Service Bulletin

Date: June 2015

Product: Select 2015 Tillers

Text: Reference **SB# B1500042**

Figure 1.

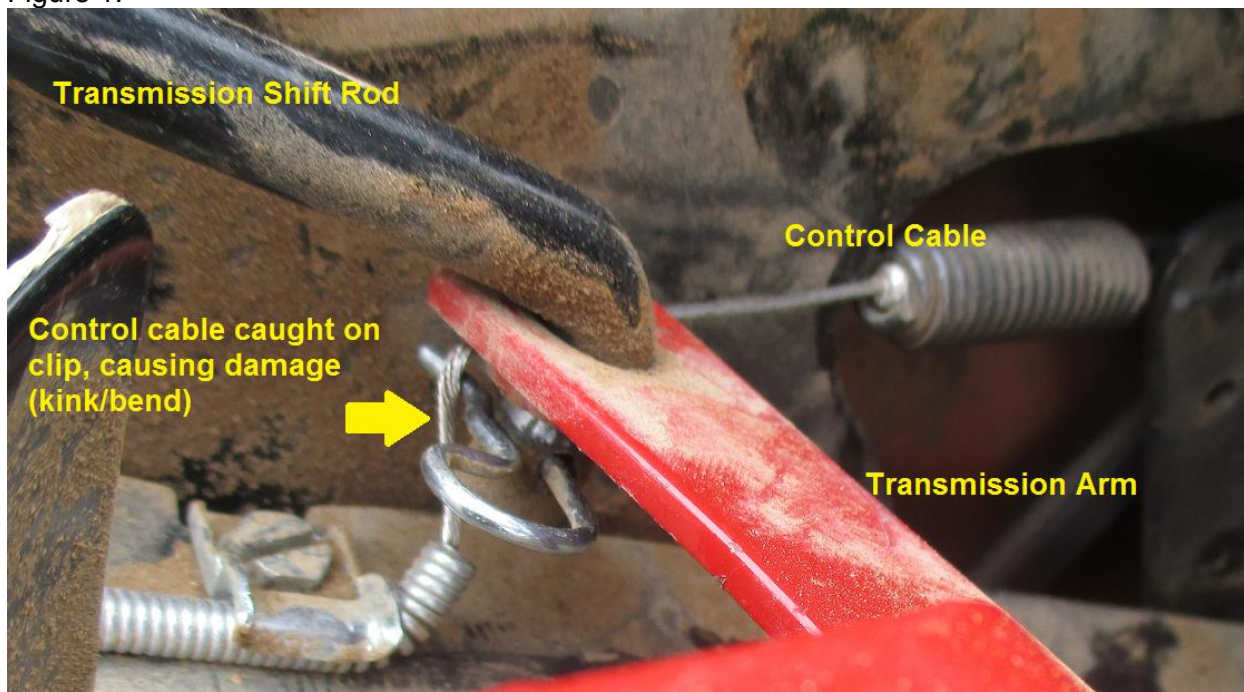
The transmission shift rod and clip are making contact with the control cable when shifting the transmission. This can cause the control cable to become kinked and/or caught, resulting in unintended engagement. See Figure 1.

Figure 3b – (transmission end)

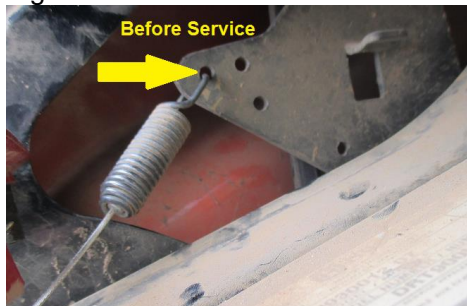
Note the position of the clip at each end of the transmission shift rod. Before service, the clip is facing down at the transmission end and the transmission shift rod enters the handle from the LH side. See Figures 3a, 3b and 3c.

8. Flip the position of the transmission shift rod so that the handle end is now near the transmission shift arm and the transmission end is near the handle.
9. Insert end of transmission shift rod to handle, entering from the RH side. Use clip to fasten into position (no washer needed).
10. Insert other end of transmission shift rod to underside of transmission shift arm, using clip on top. Fasten into position (no washer needed). The clip will now be out of contact with control cable while shifting gears.
11. Verify position of transmission shift rod is as seen in Figure 8.

Figure 6 – Control cable positioned in top hole

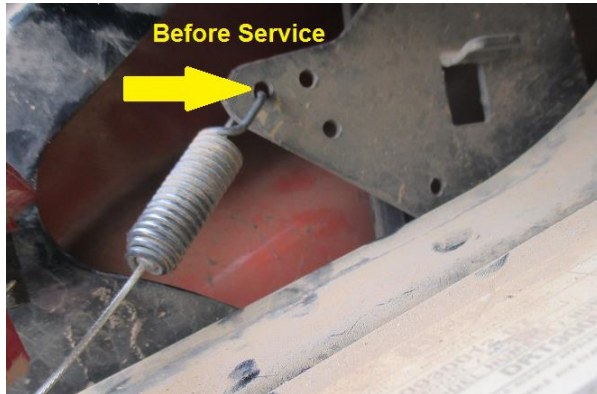
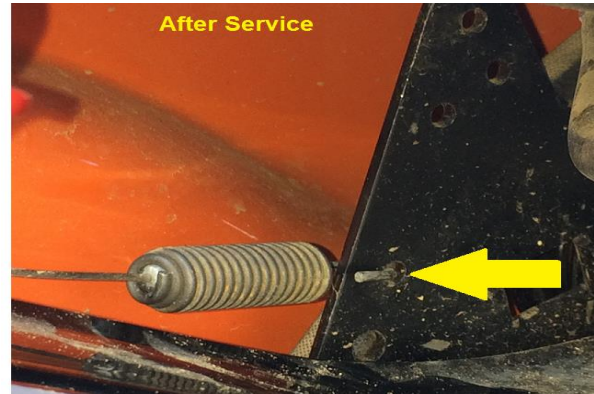
Note the position of the control cable. Before service, the cable is attached to the idler bracket through the top hole, as indicated in Figure 4. Note that the open end of the spring is facing the belt.

5. Disconnect cable from top hole in idler bracket. See Figure 6. Note: This will require loosening the screw that holds the cable. Move the shifter arm to allow access to the screw that holds the cable.
6. Reconnect control cable to lowest hole in idler bracket with the open end of the spring facing the engine side of bracket (away from belt). See Figure 7.
7. Reset cable tension. With handle in the released position (not activated), pull cable taught. Tighten screw that holds the cable. Move shifter arm back to neutral if moved in step 5.

Figure 8 – After Service

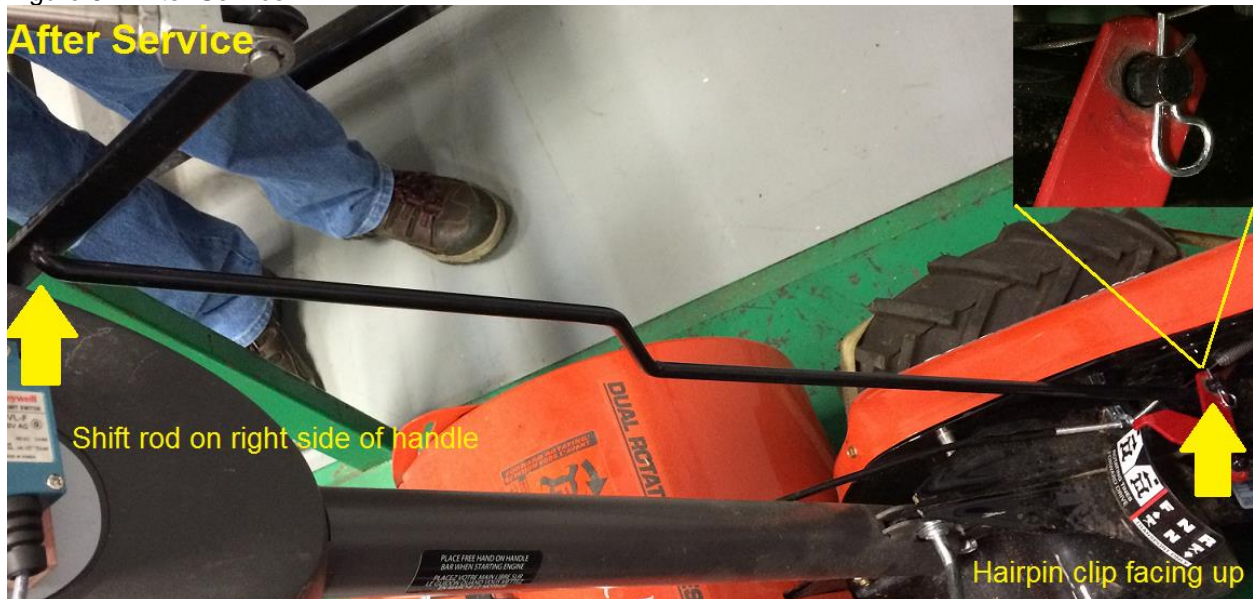
12. Move gear shift handle, checking that the control cable is not making contact with the transmission shift rod and clip.
